ERL and System Performance for 50GBASE-CR

Presented at May 2018 Pittsburgh interim.

- This presentation is related to comment r02-15, and also investigates the effect on system performance as measured by COM of changes in ERL parameters and specifications. It builds on work presented in dudek_3cd_01_0318.

Table 136–13—Transmitter and receiver ERL parameter values

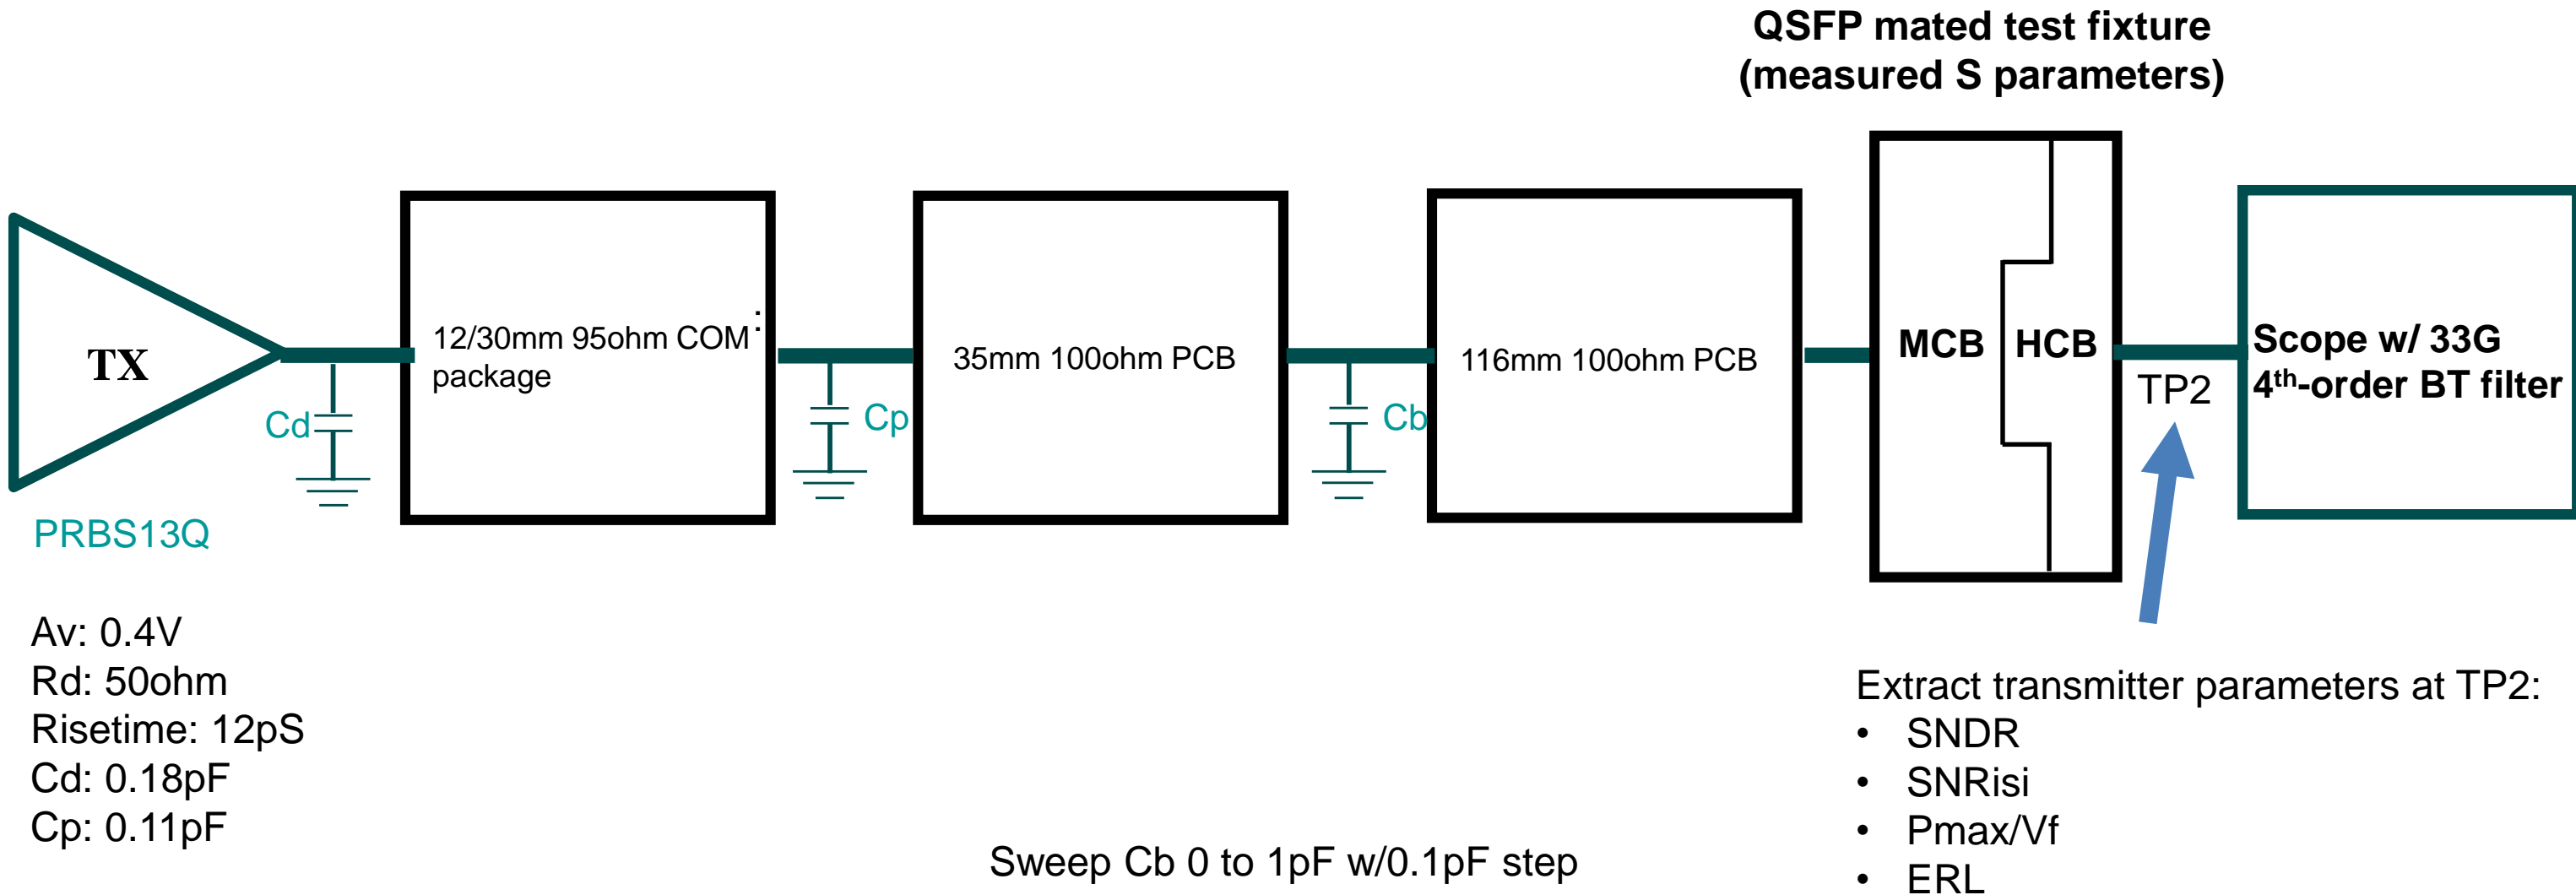
In table 136-13 page 226 change beta x to 1.7 and rho_x to 0.3

COM vs. Host ERL (comment: rho=0.3 beta_x=1.7 N=300 Grr_limit=1) Original slide per spreadsheet on slide 14

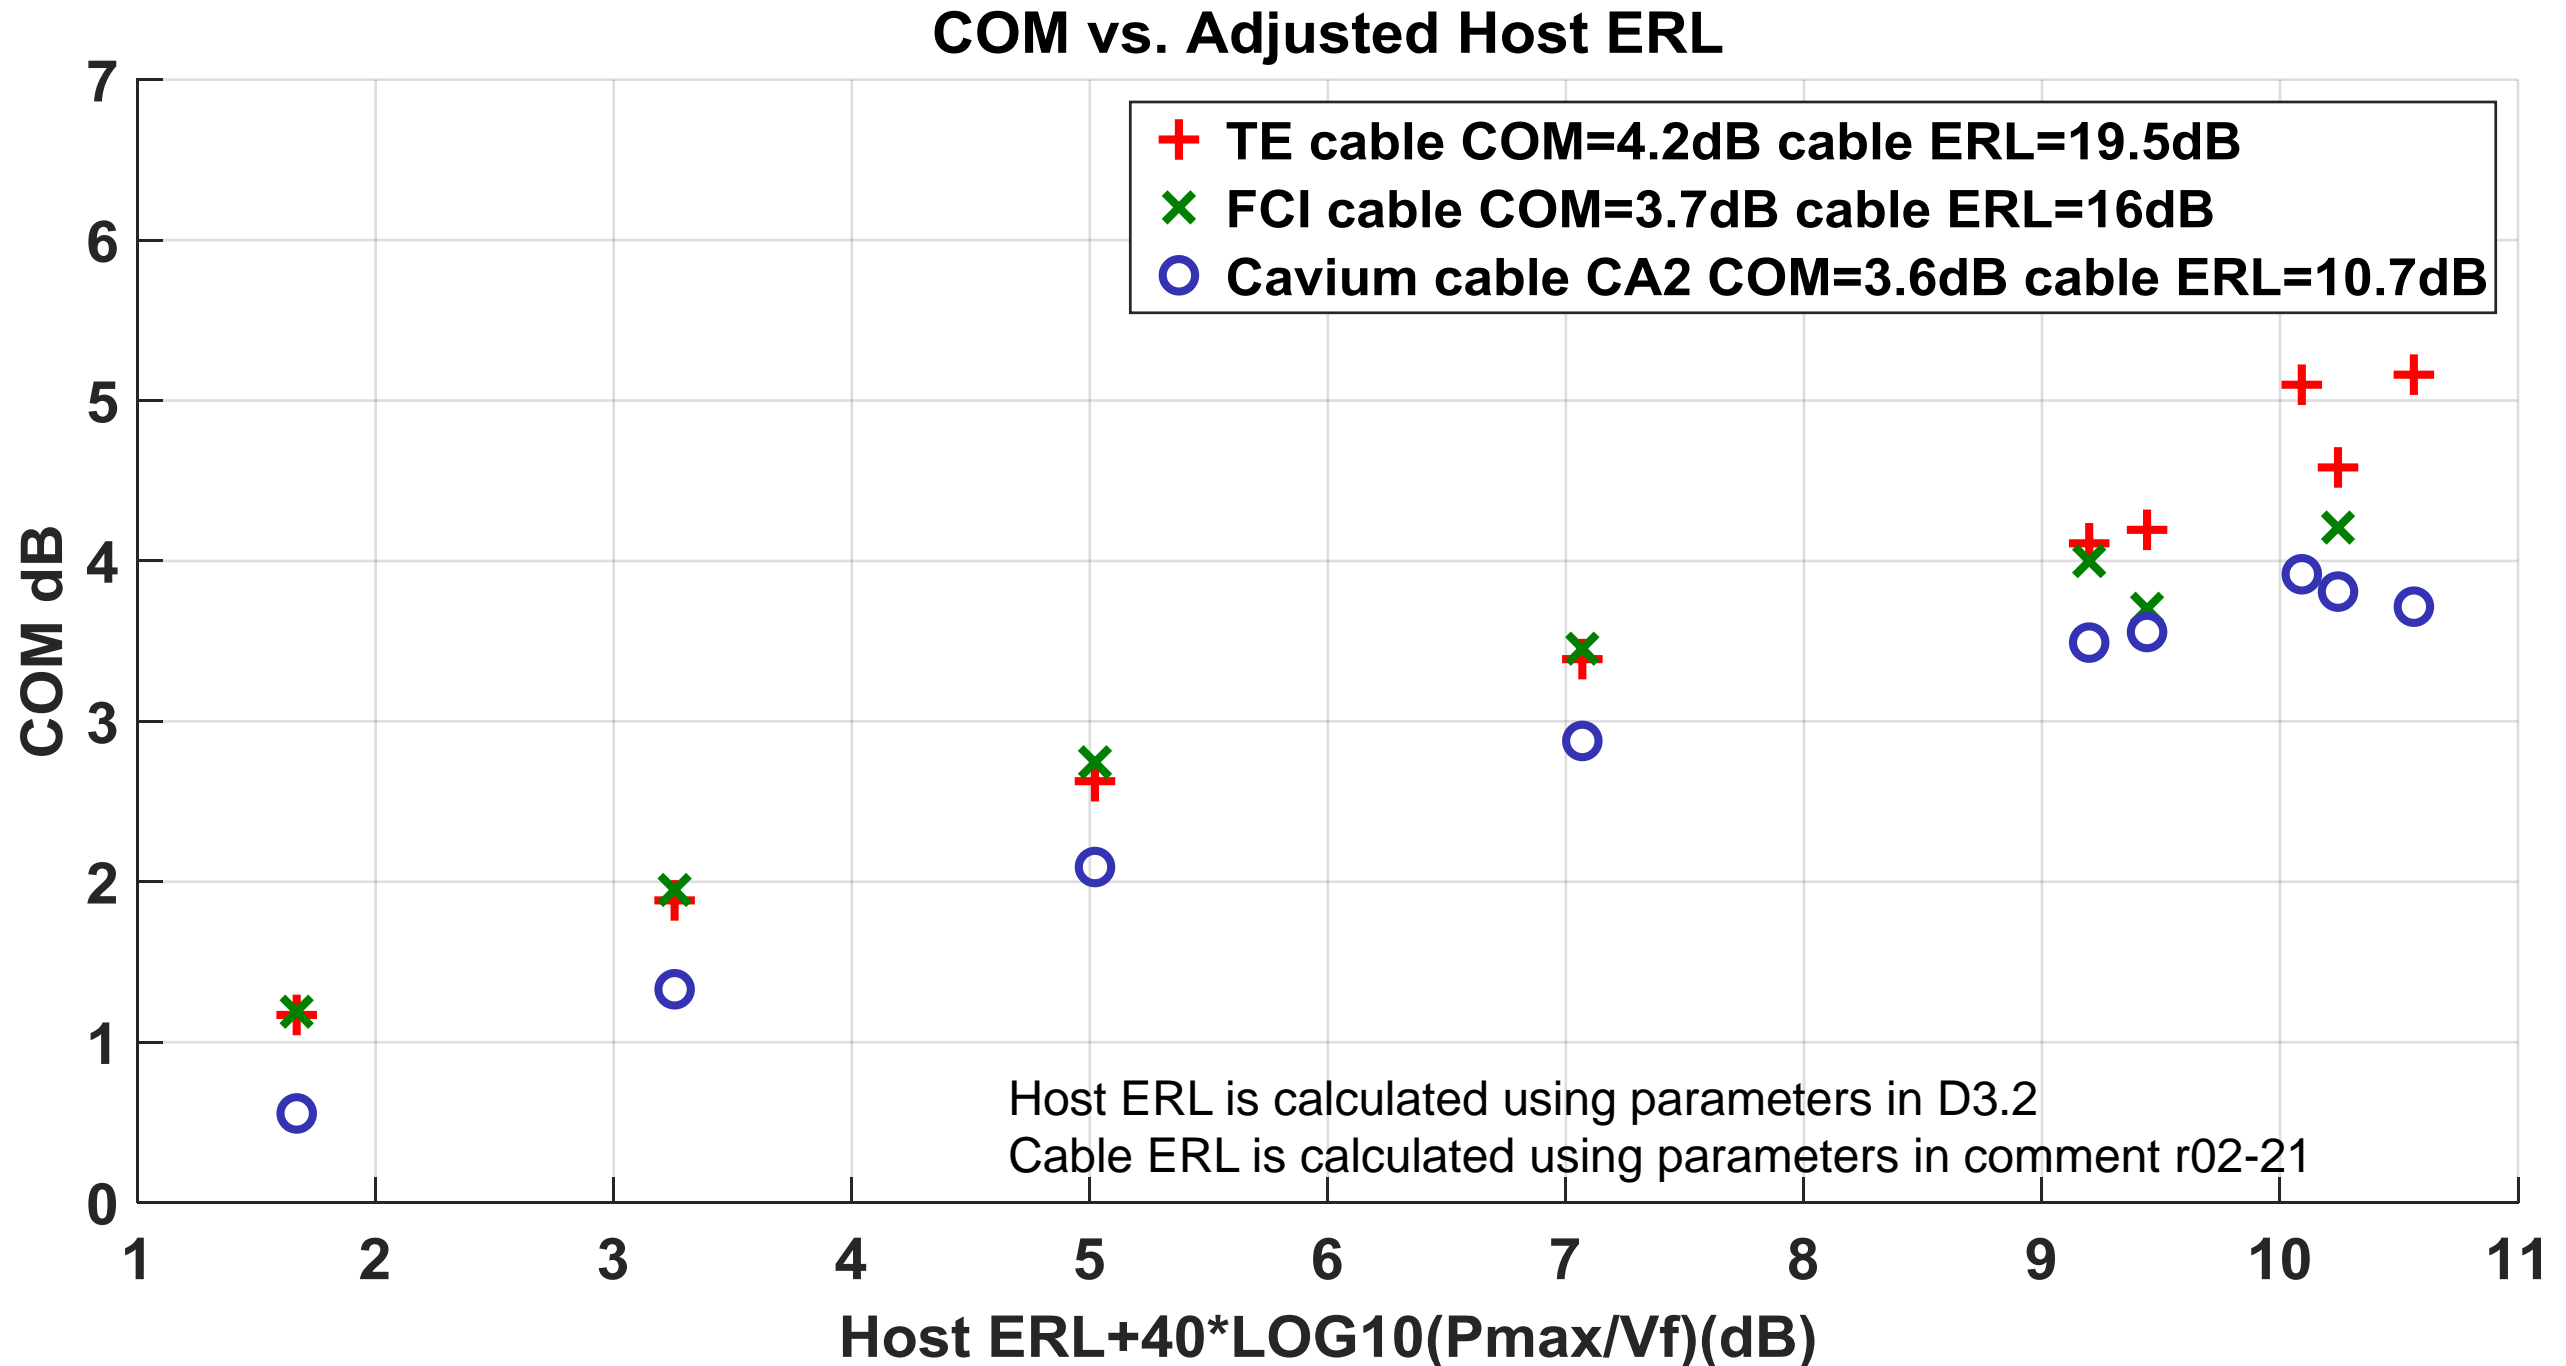
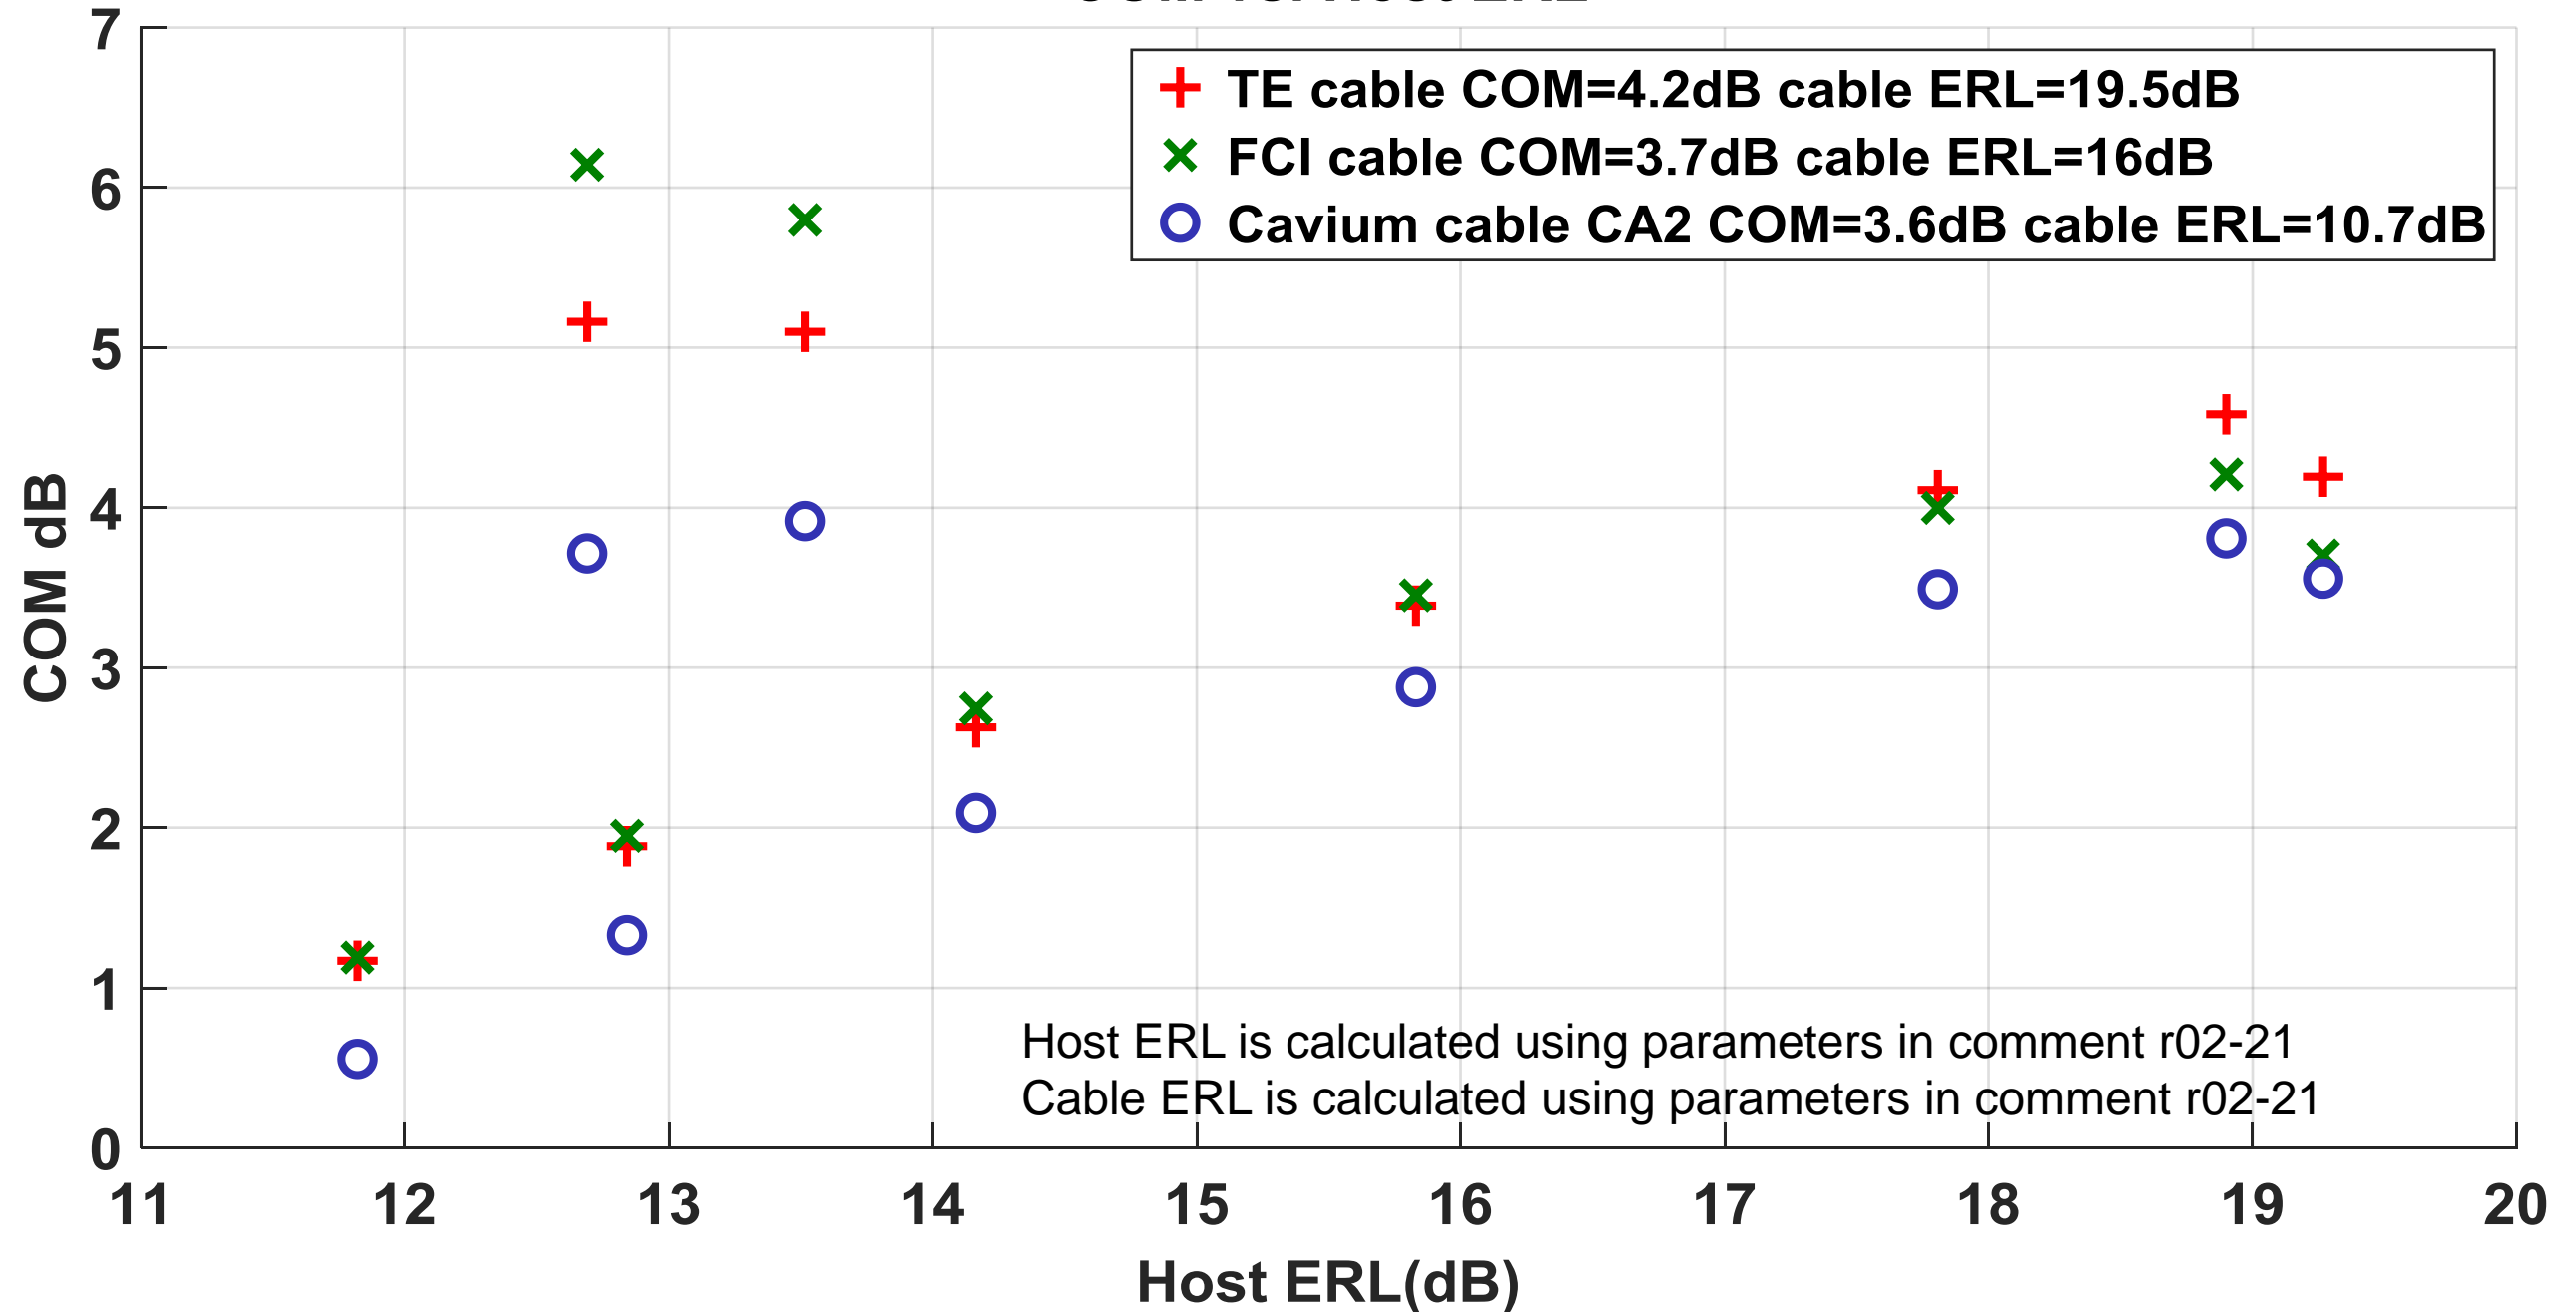
- **The proposed changes to the ERL parameters result in different ERL values (approximately 3dB lower). There are technical justifications for the changes and we recommend they are accepted but the ERL pass/fail limit needs to be adjusted.**
- **The short hosts provide good system performance on these cables and are a likely implementation. They should pass the Tx specification.**
- **The long host with the Cb capacitance at 0.3pF provides bad system performance on all these cables (and particularly CaviumCA2). It should fail the Tx specification.**
- **It has been proposed that the specification should be a single value of ERL, a single value of SNR_{Risi} or a combination of a single value of ERL plus a single value of SNR_{Risi} however no single values for these parameters exists that will not have false passes or false fails with these hosts.**

- **The new ERL parameters should be adopted.**
- **A specification of $ERL \geq 4dB - 40 * \text{Log}_{10}(P_{max}/V_f)$ should then be adopted.**
- **Note that it has been suggested that it is inconvenient having this combined specification as ERL is generally measured with a VNA and post processing and P_{max}/V_f is measured with an oscilloscope and post processing. With this specification however test engineering could choose to use fixed pass/fail values for the testing of their product depending on the product type with a choice of paired values. E.g.**
 - $P_{max}/V_f \geq 0.49$ $ERL \geq 16.4$
 - $P_{max}/V_f \geq 0.55$ $ERL \geq 14.4$
 - $P_{max}/V_f \geq 0.63$ $ERL \geq 12.0$
